DC1317A-B ASSY TOP

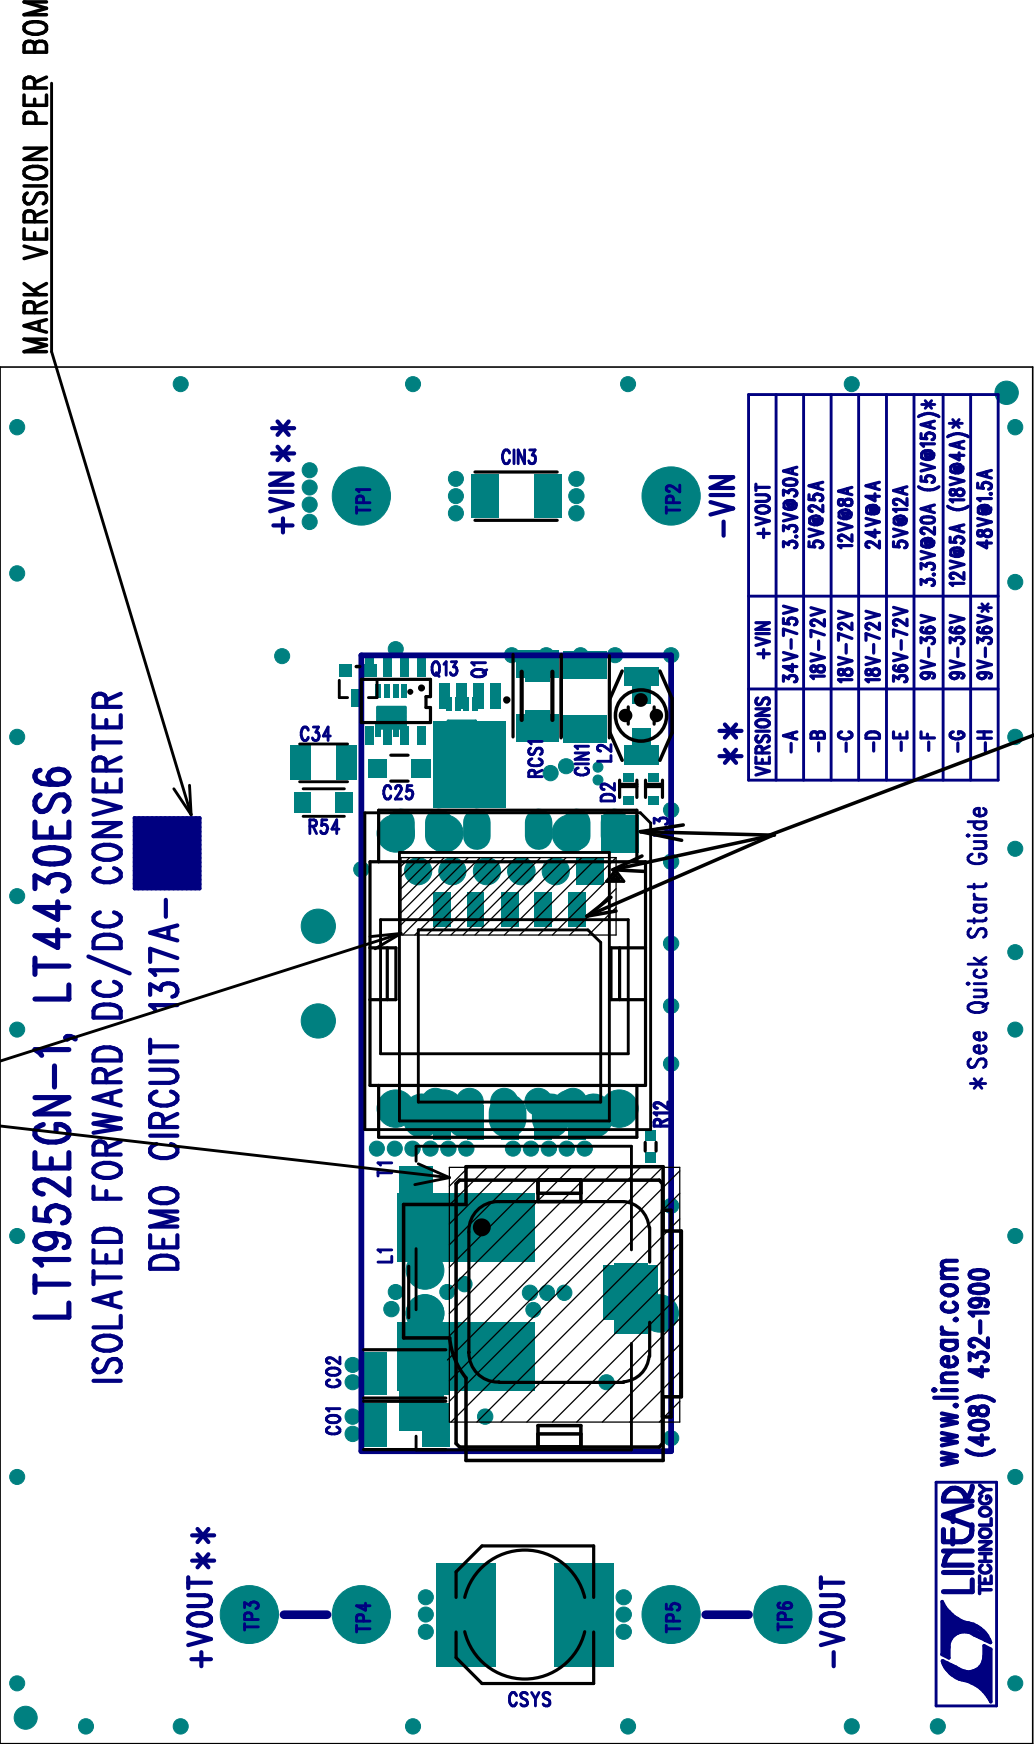
Because of multiple footprint in this design.
Place a piece of kapton tape on board as shown
to insulate T1 and L1 from open copper. No solder
under kapton tape area (tape off the stencil opening
for not used pads under T1 and L1).
